Bid Due date: Monday, May 6, 2024, at 1:30 PM Local Time (UNCHANGED)

II. Questions and Answers

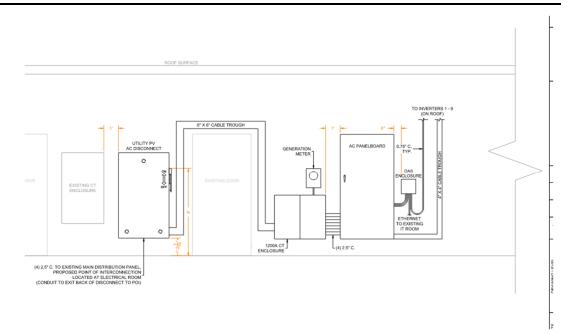
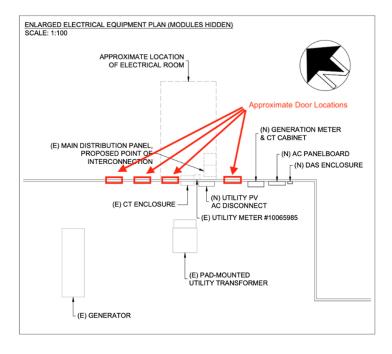
- Q8. Can you clarify or confirm the AC Panelboard collector location?
- A8. Per the preliminary DTE Feedback & Drawing Set included in the bid package, the AC Panelboard will be located on the Southwest exterior wall near the Electrical Room. The possibility of DTE requiring additional disconnect between the meter and AC Panelboard exists pending DTE feedback. The contractor may be required to move the current signage on the building. If a roof penetration is required, roof penetration is to be provided by the District's roofing contractor. See site photos and drawing excerpts below.
